**NORTHEAST UTILITIES**

December 23, 1991

Re: Employee Concerns

Millstone Nuclear Power Station, Unit No. 2  
RI-91-A-0231

Figure 1

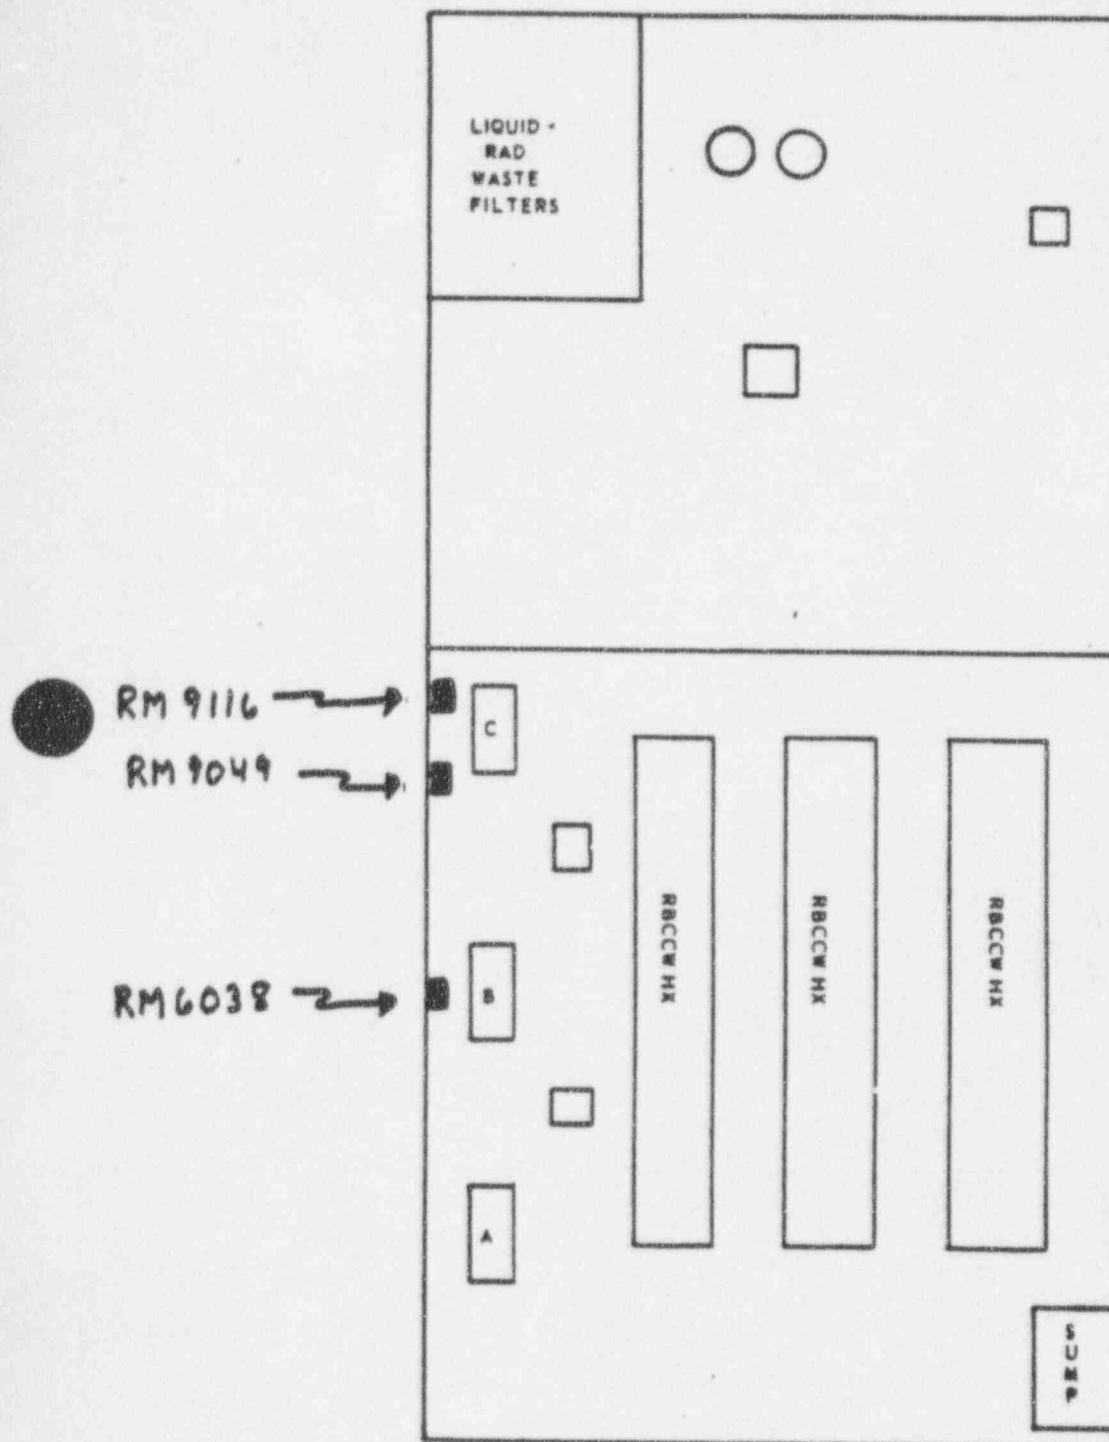
The RBCCW radiation monitor (RM 6083) sample valves are not labeled. Additionally, the piping and instrumentation drawing (P&ID) 25203-26022, Sheet No. 1, does not reflect the actual installed configuration of the sample lines. (This concern is similar to issue 210-1 referred to you by letter under File Number RI-91-A-0210, dated August 22, 1991.)

With respect to the P&ID sheet, this assertion is a true statement but does not represent a valid safety concern. The drawing at issue has been checked against actual system and the installed configuration of the sample lines was correct. However, a difference was found in that the lead brick shielding, which was removed when the monitor was upgraded to a unit not requiring additional shielding, is still shown on the drawing. A drawing change has been issued to eliminate the lead bricks shown on the P&ID.
